HISTORIC AND DESIGN REVIEW COMMISSION

May 19, 2021

HDRC CASE NO: 2020-436
ADDRESS: 245 W WILDWOOD
LEGAL DESCRIPTION: NCB 9013 BLK 7 LOT 69 70 AND 71
ZONING: R-4, H
CITY COUNCIL DIST.: 1
DISTRICT: Olmos Park Terrace Historic District
APPLICANT: MCGOVERN TIMOTHY J & CHELSEA
OWNER: MCGOVERN TIMOTHY J & CHELSEA
TYPE OF WORK: Construction of a 1-story rear addition, fenestration modifications, exterior alterations
APPLICATION RECEIVED: May 07, 2021
60-DAY REVIEW: Not applicable due to City Council Emergency Orders
CASE MANAGER: Rachel Rettaliata
REQUEST:

The applicant is requesting conceptual approval to:

Proposed Design Floor Plan
 (shown with Property Bounds in light green)
 SCALE: 1/8" = 1' (1:96)

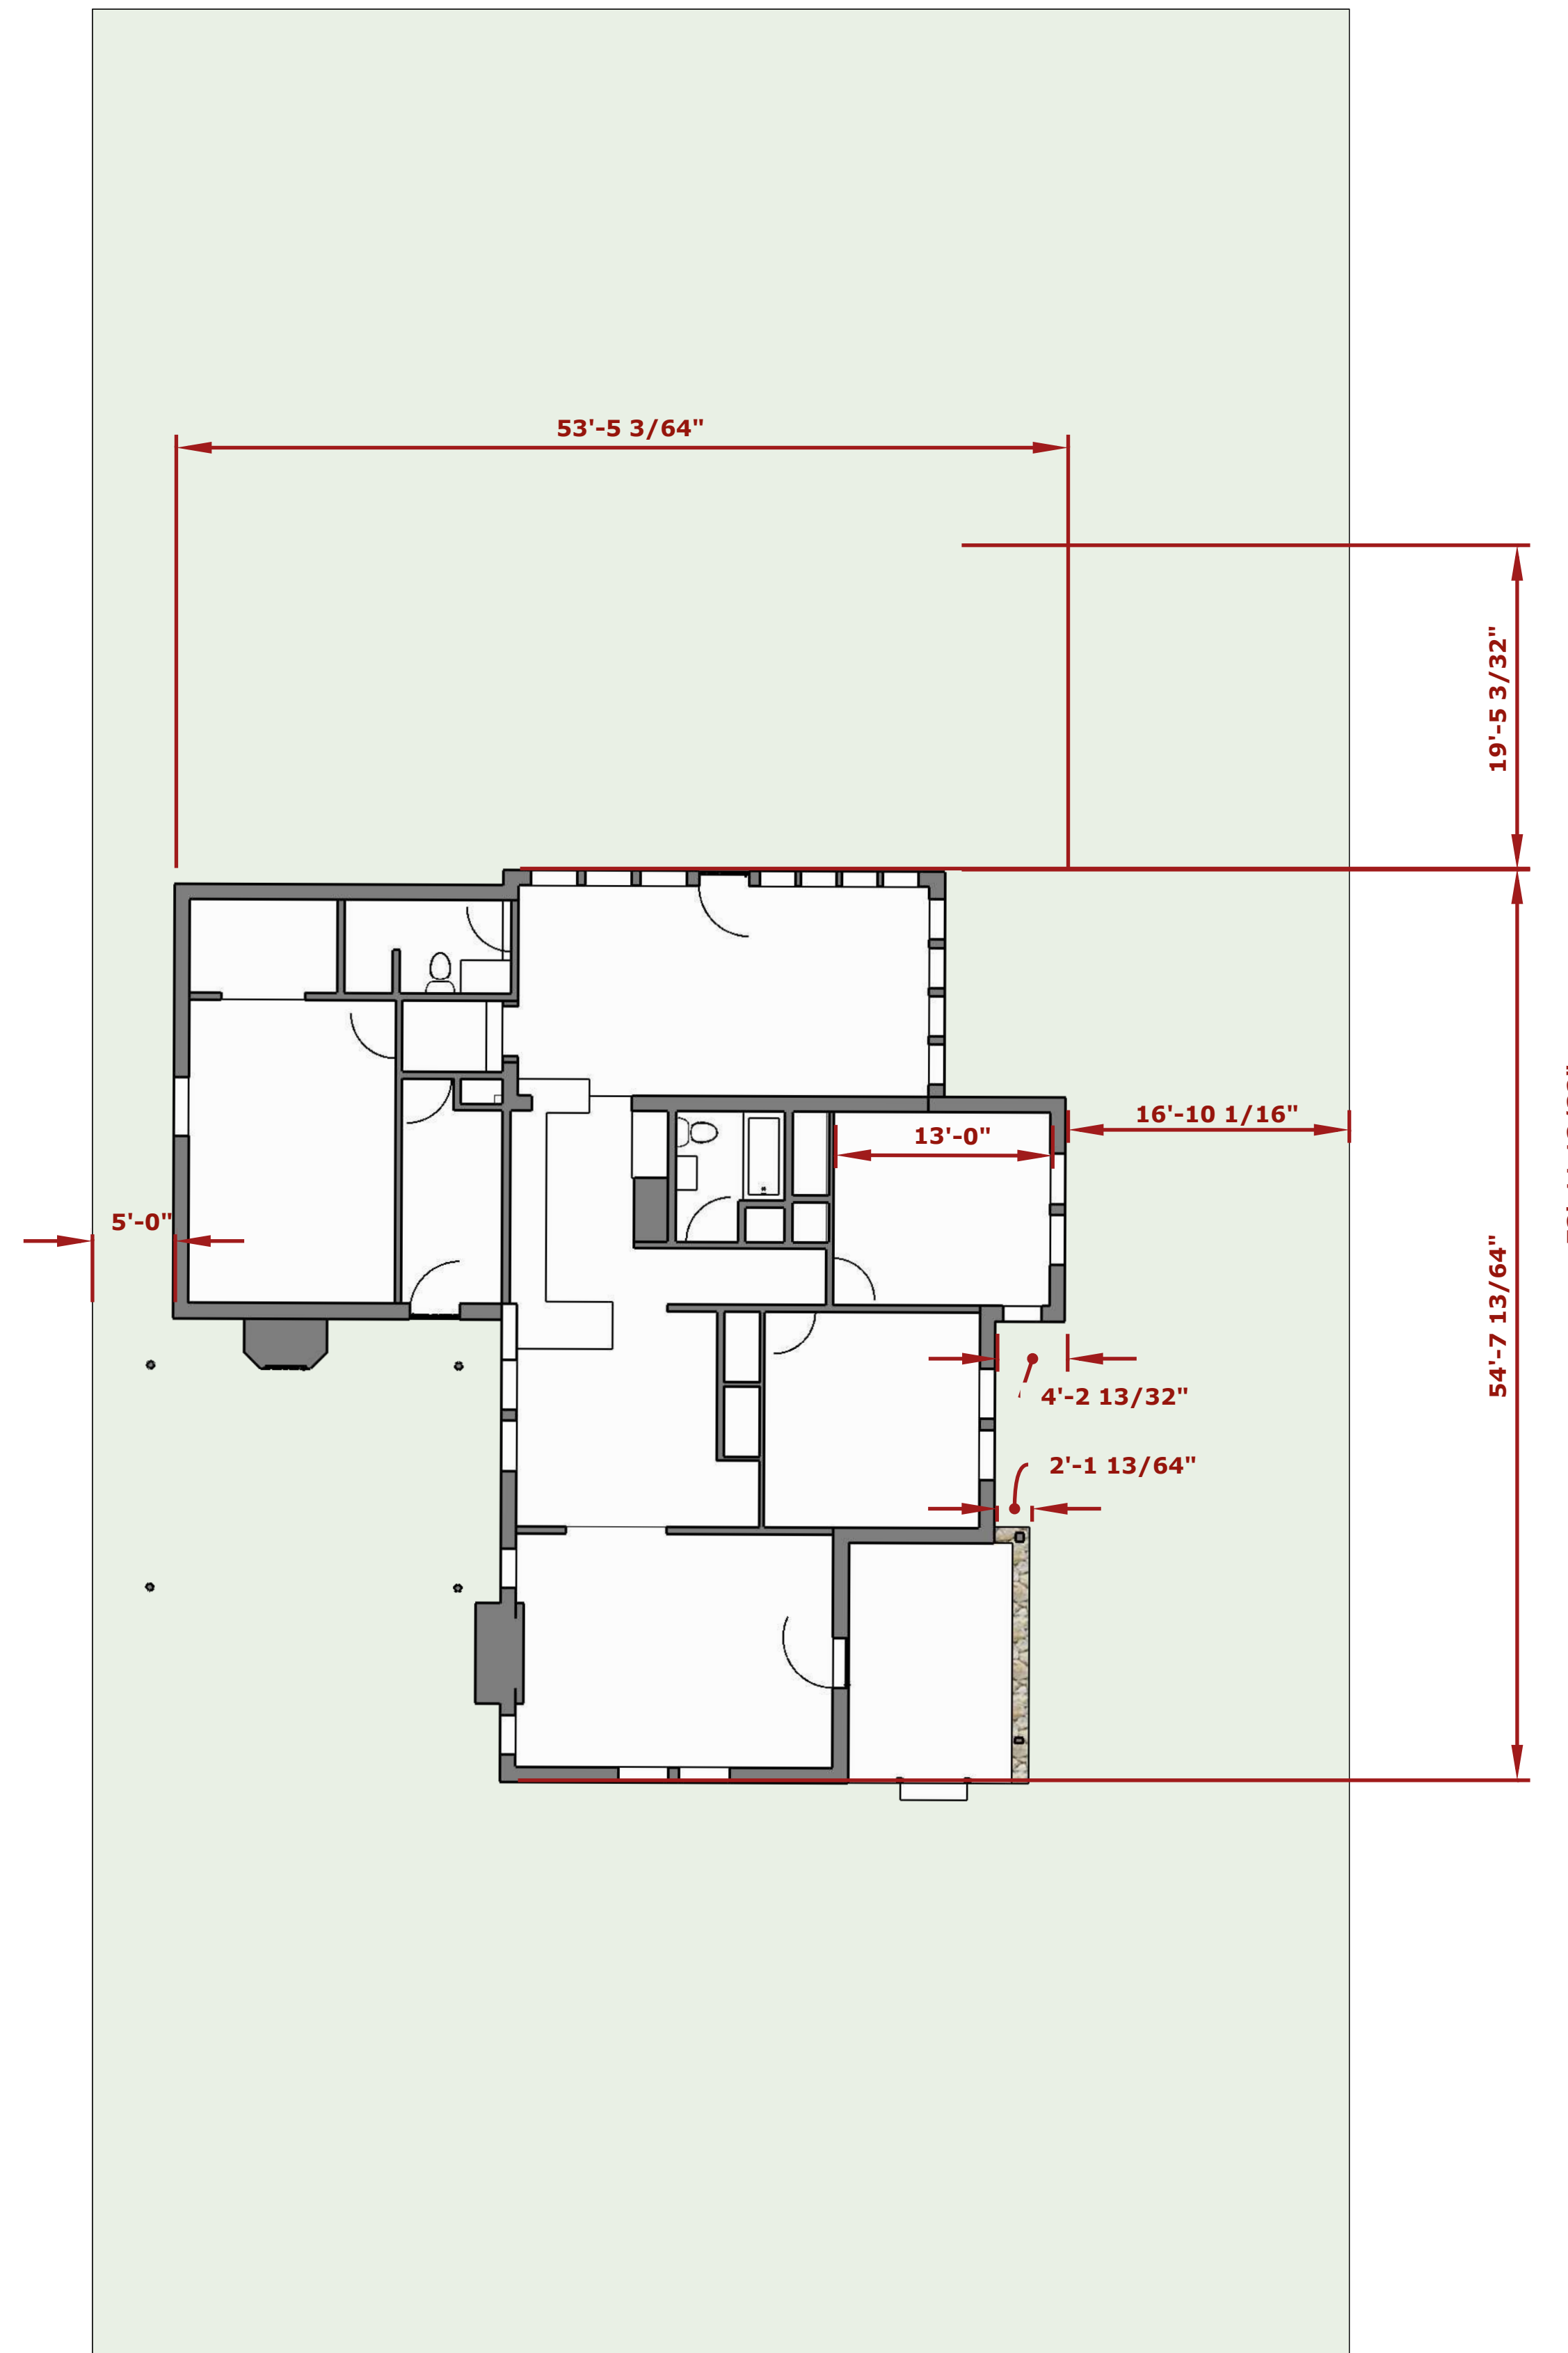
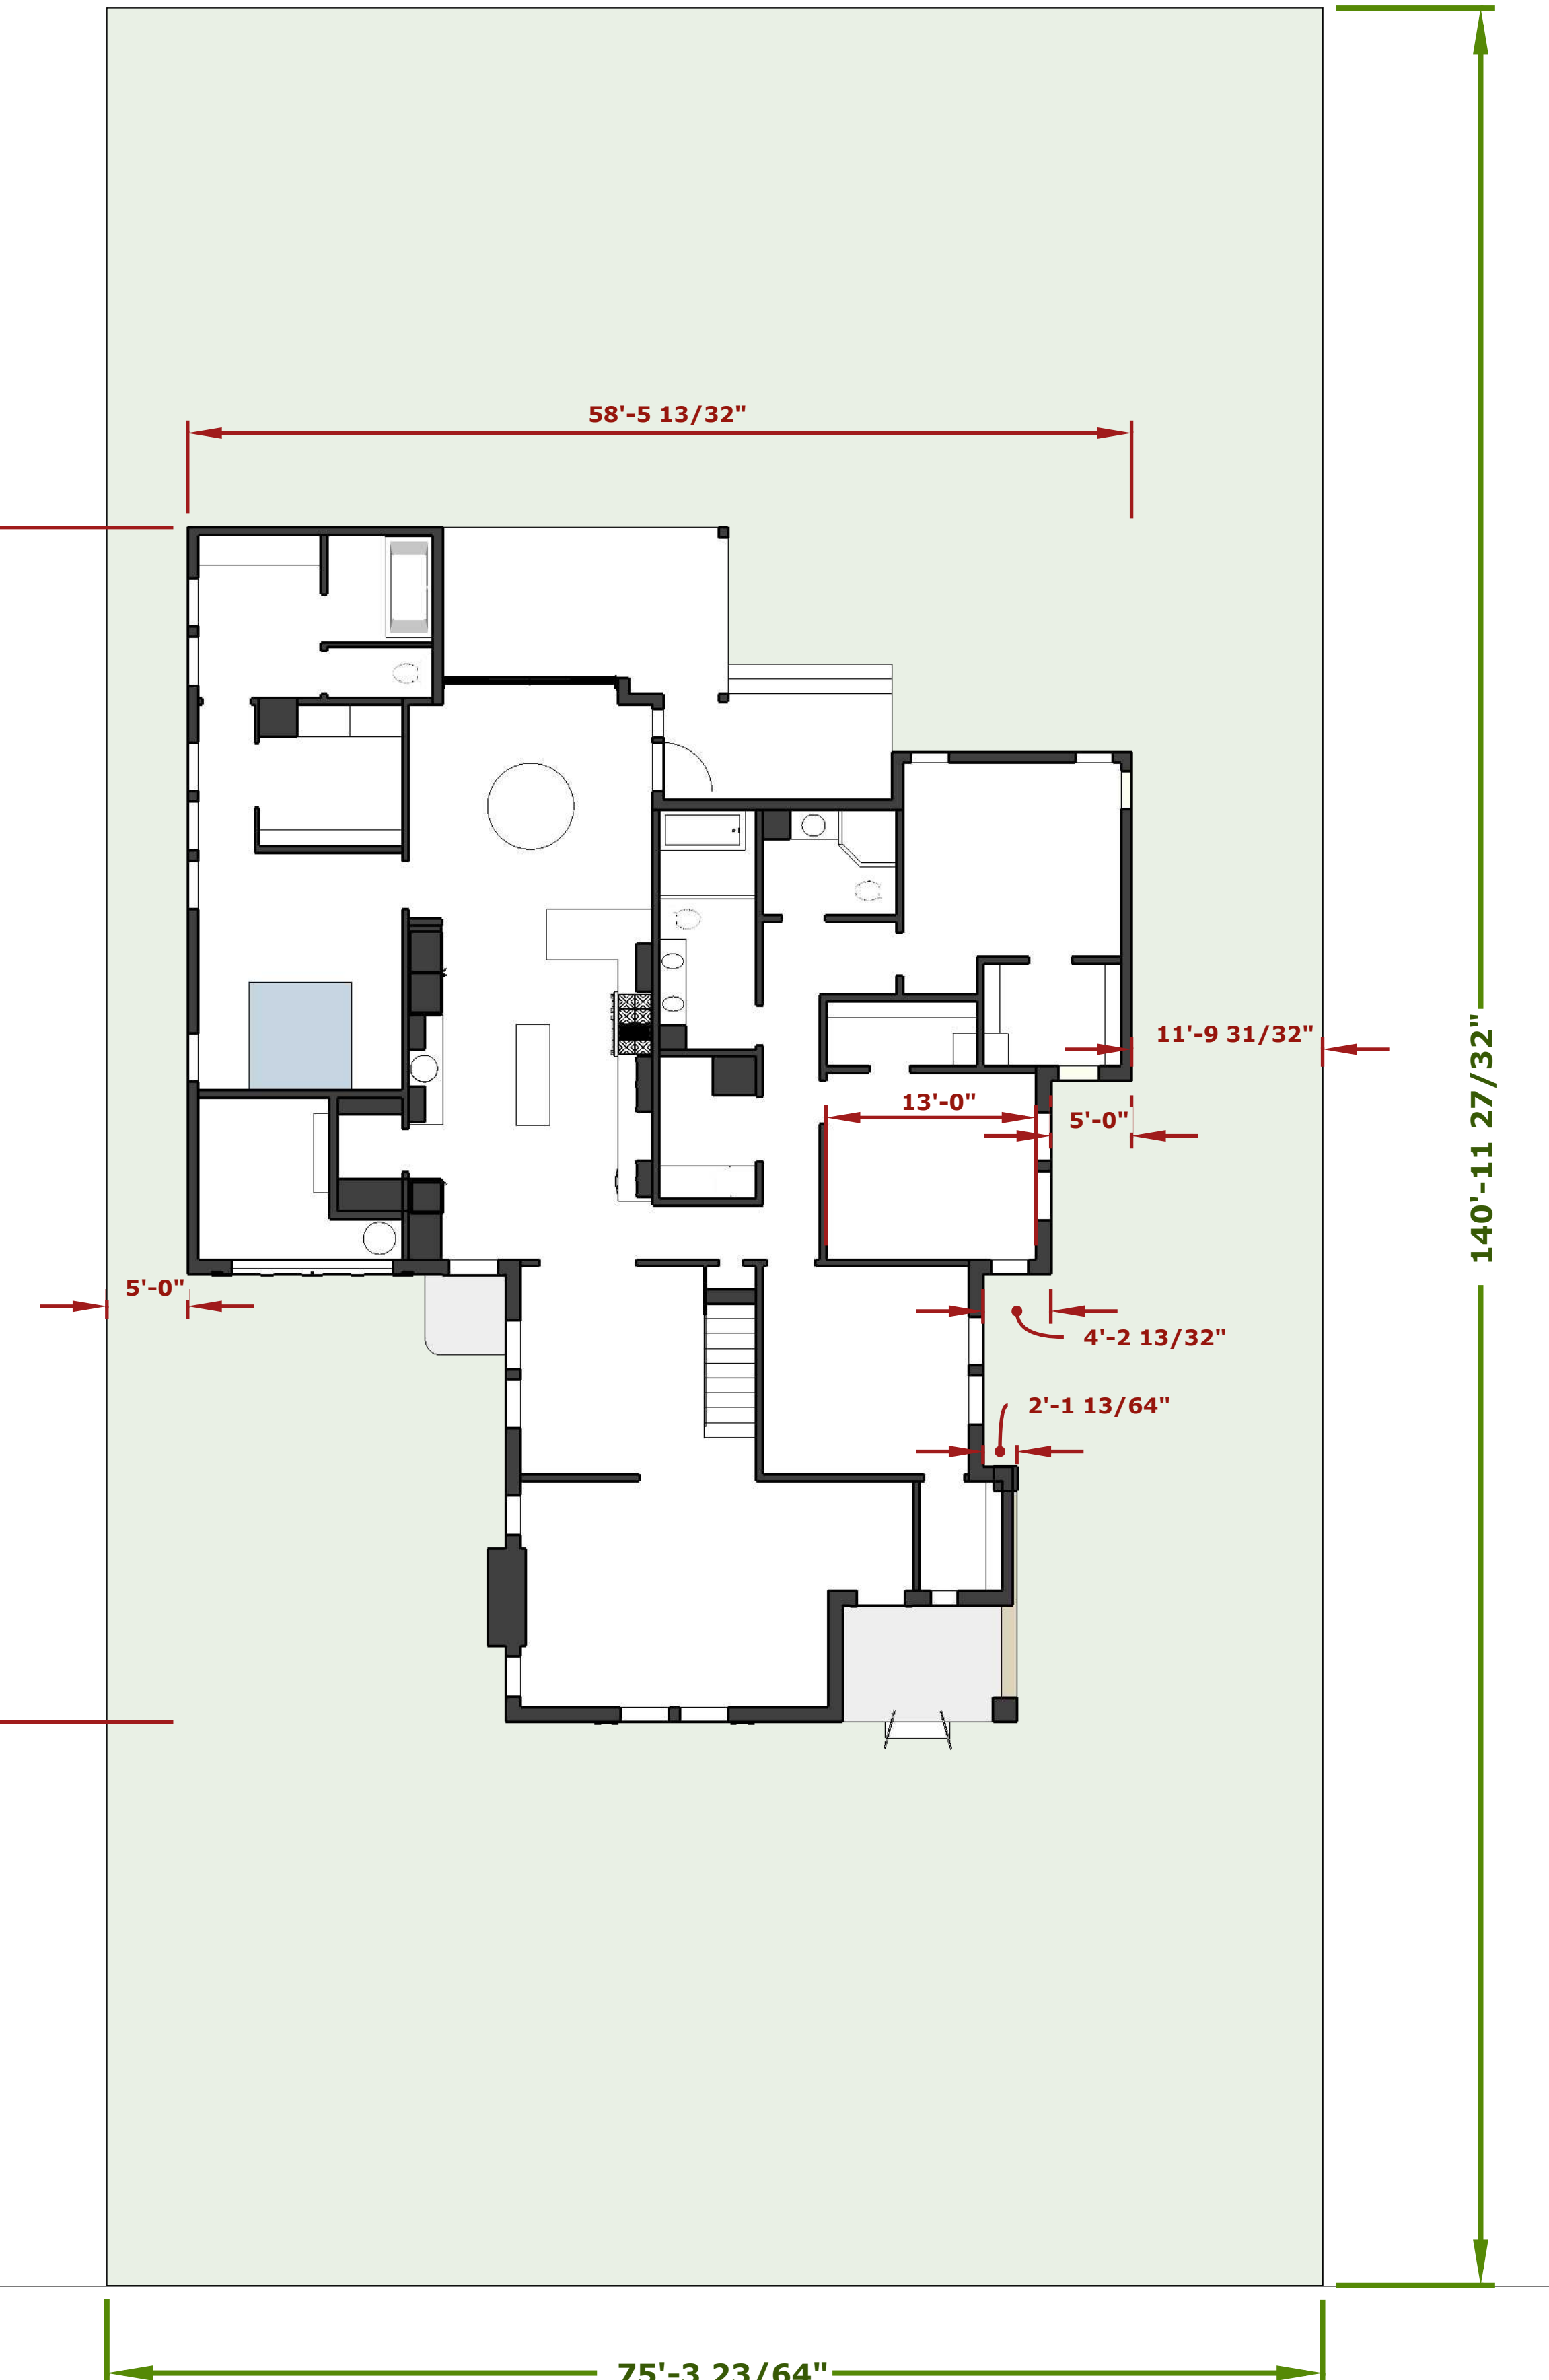
- e. **ADDITION: MASSING AND FOOTPRINT** – The applicant has proposed to construct a 1-story rear addition that will extend the width of the house and will replace an existing enclosed porch rear addition. The rear addition will be approximately 1,000 square feet. The portion of the addition sited on the northeast side of the property is proposed to extend 5 feet east past the existing structure but will be located behind an existing rear privacy fence line. Guideline 1.A.i. for Additions states that residential additions should be sited at the rear of the building whenever possible to minimize views of the addition from the public right-of-way, an addition to the front of a building would be inappropriate. Guidelines 1.A.ii. for Additions states that new residential additions should be designed to be in keeping with the existing, historic context of the block. For example, a large, two-story addition on a block comprised of single-story homes would not be appropriate. According to Guideline 1.B.v, the height of new additions should be determined by examining the line-of-sight or visibility from the street. Addition height should never be so contrasting as to overwhelm or distract from the existing structure. The Guidelines stipulate that residential additions should not be so large as to double the existing building footprint, regardless of lot size. The existing building is 2,000 square feet. Staff finds the proposed footprint appropriate.

Item 1, staff recommends conceptual approval of the request to construct a rear addition based on findings a through k. Staff recommends that the applicant address the following stipulations prior to returning to the HDRC:

- i. That the applicant proposes a fenestration pattern, window opening proportions, and materials that are more consistent with the Guidelines, the Standard Specifications for Windows in Additions, and the historic examples found in the Olmos Park Terrace Historic District as noted in findings h through j.
- ii. That the applicant submits final material specifications for wood or aluminum clad wood windows as noted in finding j. Windows should feature an inset of two (2) inches within facades and should feature profiles that are found historically within the immediate vicinity. An alternative window material may be proposed, provided that the window features meeting rails that are no taller than 1.25” and stiles no wider than 2.25”. White

manufacturer's color is not allowed, and color selection must be presented to staff. There should be a minimum of two inches in depth between the front face of the window trim and the front face of the top window sash. This must be accomplished by recessing the window sufficiently within the opening or with the installation of additional window trim to add thickness. Window trim must feature traditional dimensions and an architecturally appropriate sill detail. Window track components must be painted to match the window trim or be concealed by a wood window screen set within the opening.
